November 17, 2020

**Re: Proposed Annular Conductivity Device Demonstration Submitted in Support of  
Application for Underground Injection Control Permit, Florence Copper Project,  
Florence, Arizona**

FIGURE A-17

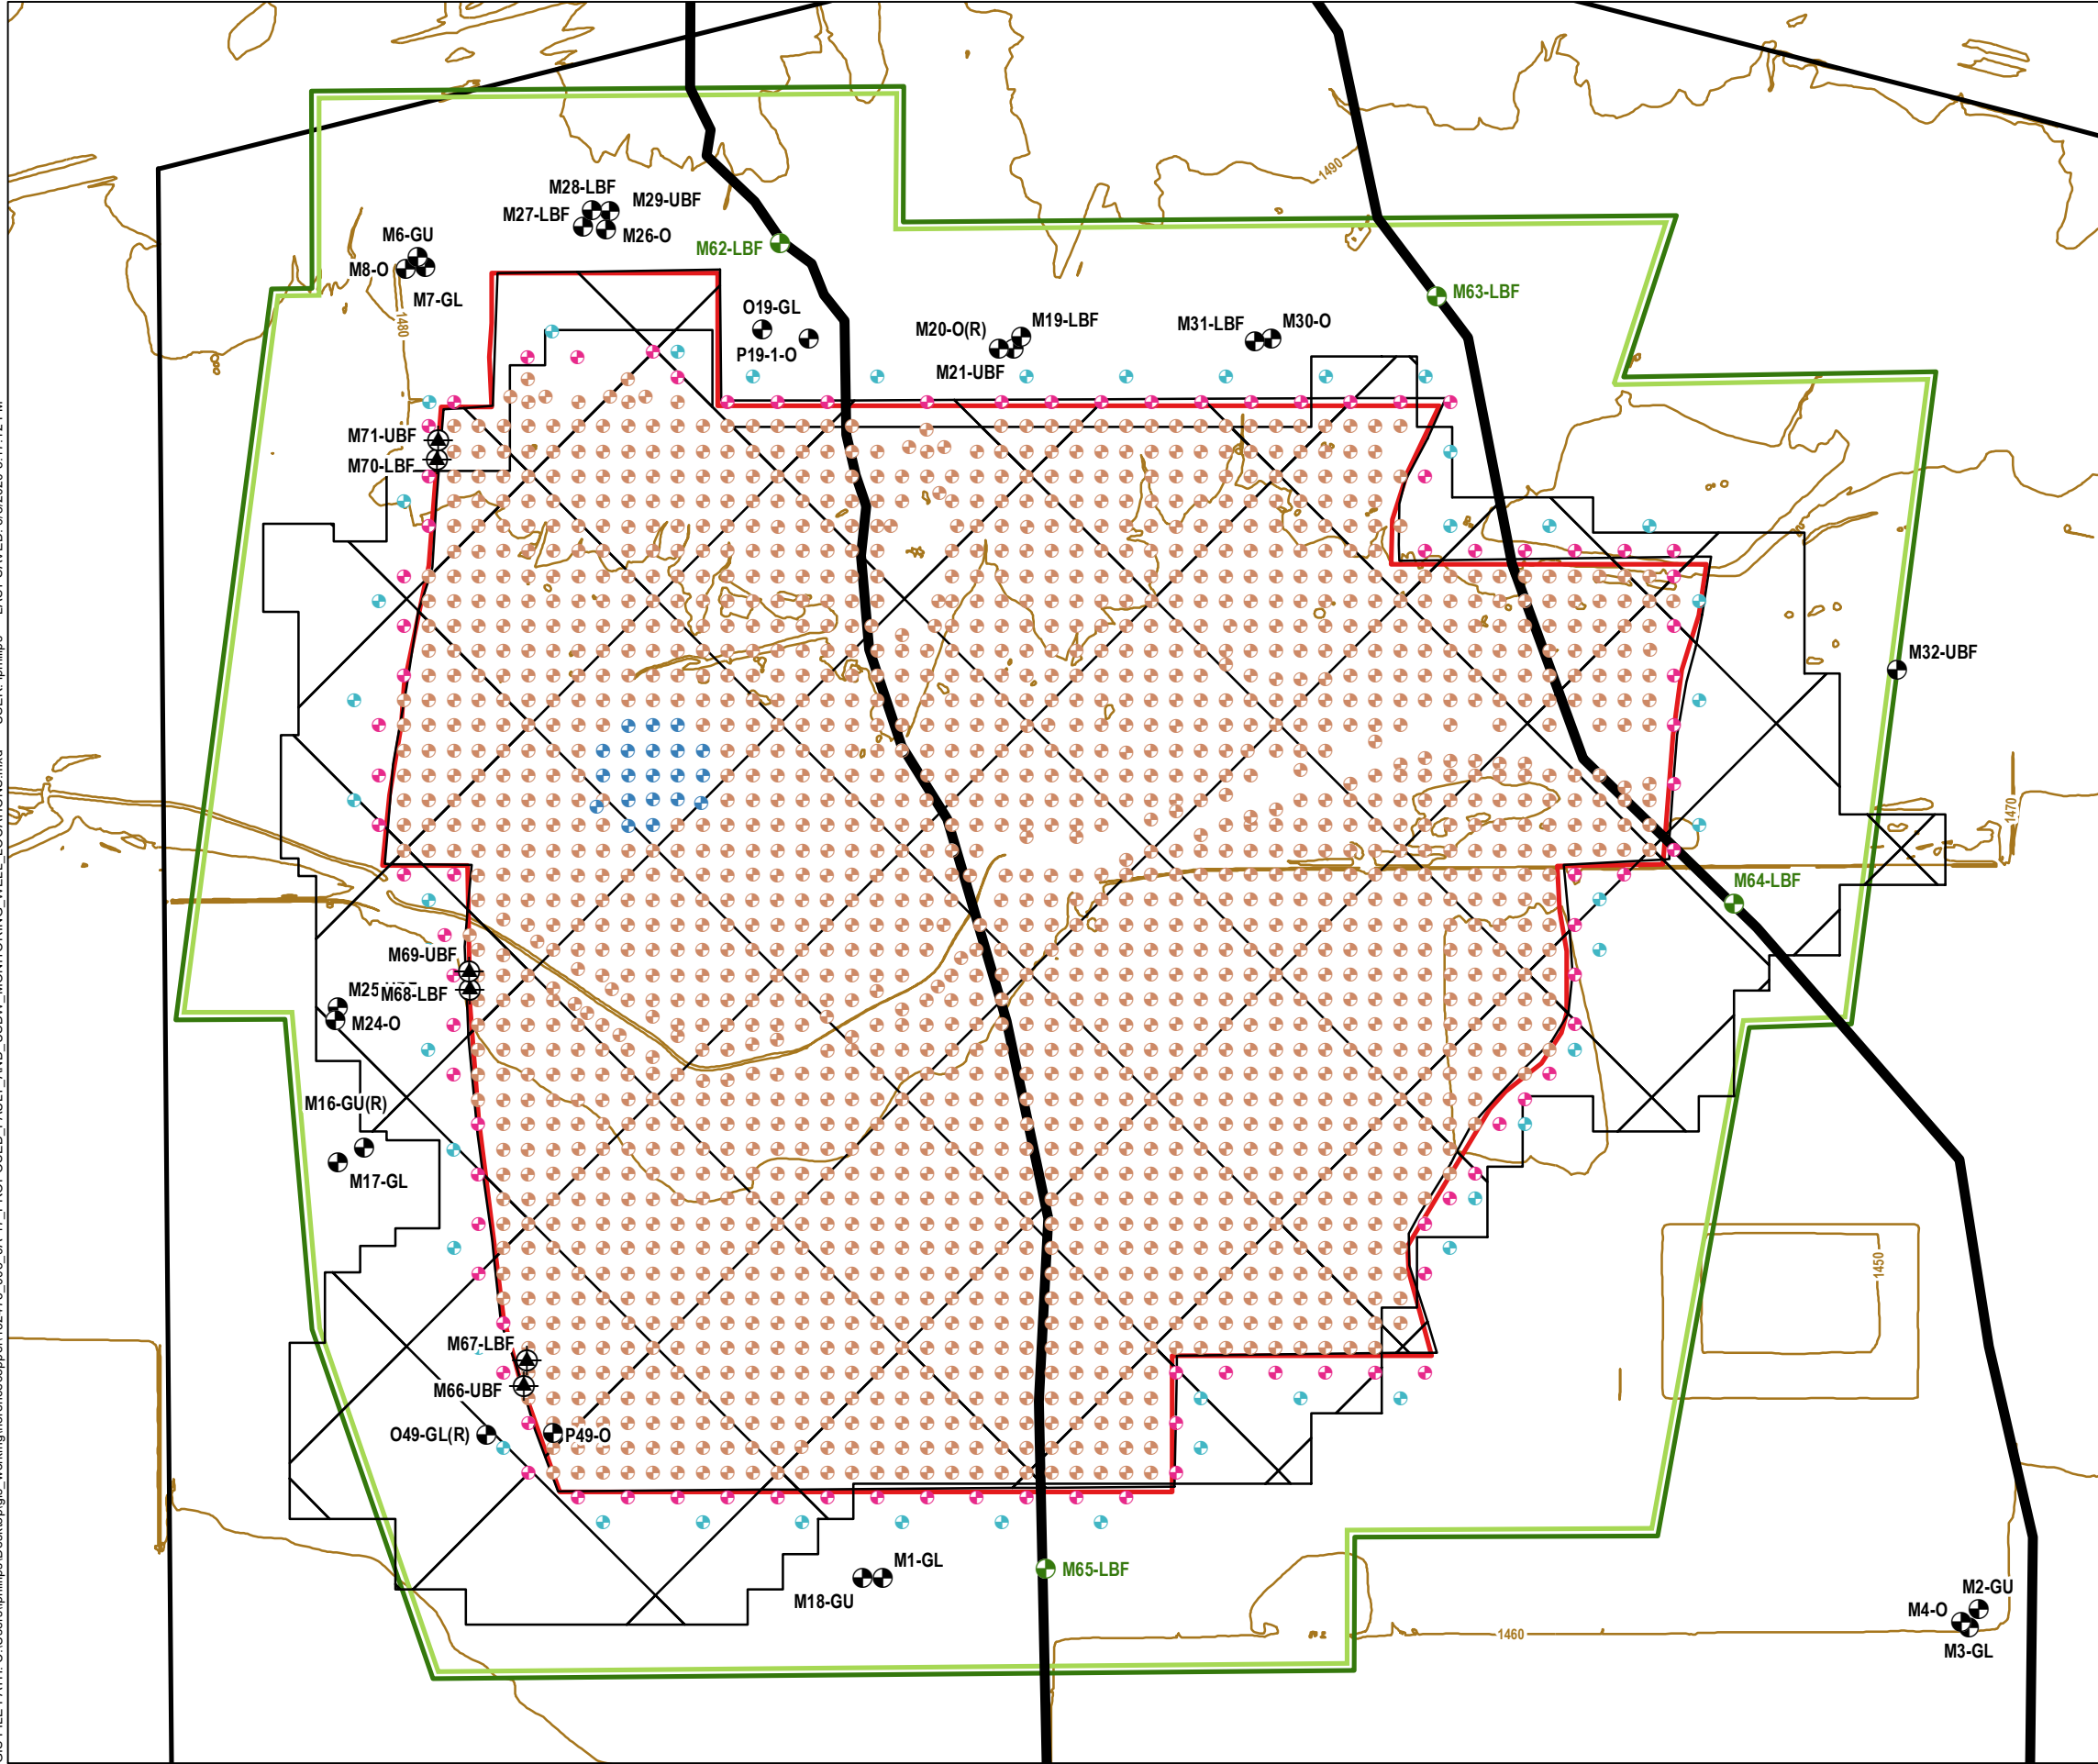
The proposed ACD installation described above will result in two ACDs installed on every injection, recovery, observation, and perimeter well in the ISCR wellfield. ACDs will also be installed on monitoring wells (fault monitoring wells and USDW monitoring wells) constructed within the Area of Review (AOR). The location of the fault monitoring wells and USDW wells are shown on Figure A-17, and the location of the first year wellfield development is shown on Figure A-19.

FIGURE A-19

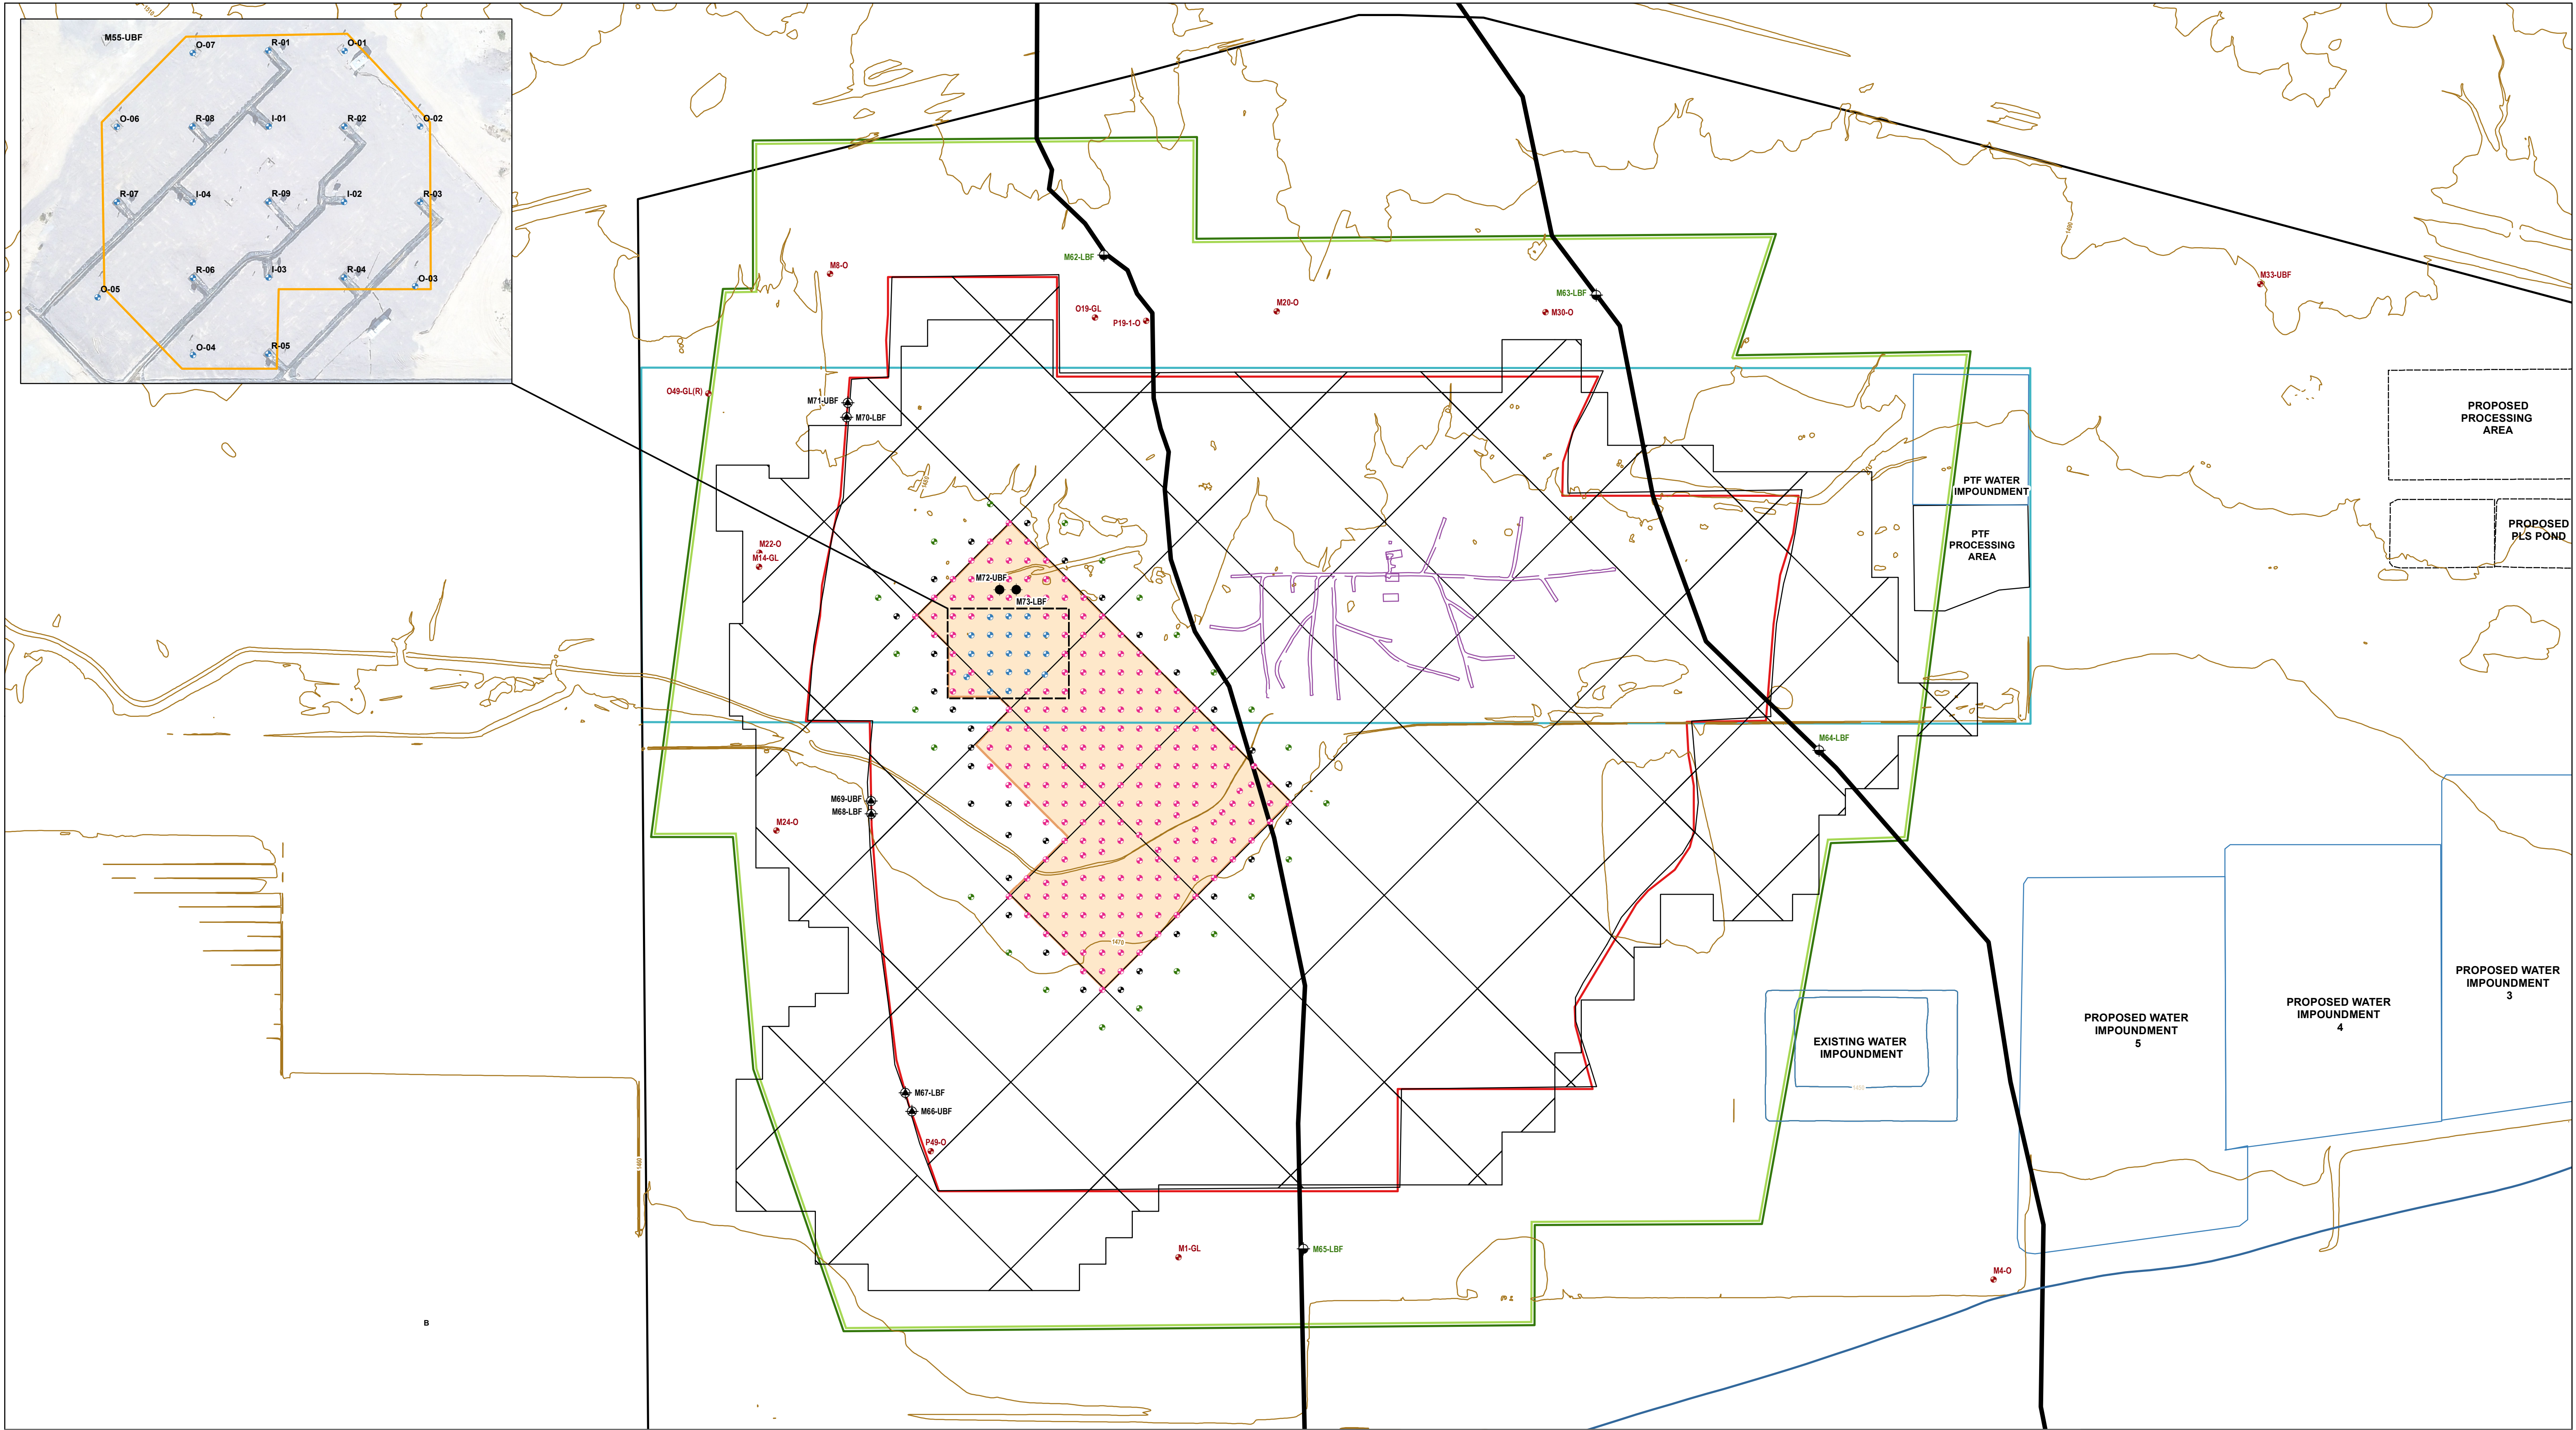
Prior to conducting the ACD demonstration, Florence Copper will install two monitoring wells in the first resource block to be developed and brought online. The wells (M72-UBF and M73-LBF) will be sited based on the location of known faults and/or areas of known higher fracture intensity. Well M72-UBF will be completed in the upper basin fill unit, with a 10-foot well screen installed within 20 feet of the top of the MFGU. Well M73-LBF will be completed in the LBFU, with a 10-foot well screen installed within 20 feet of the bottom of the MFGU. The approximate locations of monitoring wells M72-UBF and M73-LBF are shown on the revised version of Figure A-19.
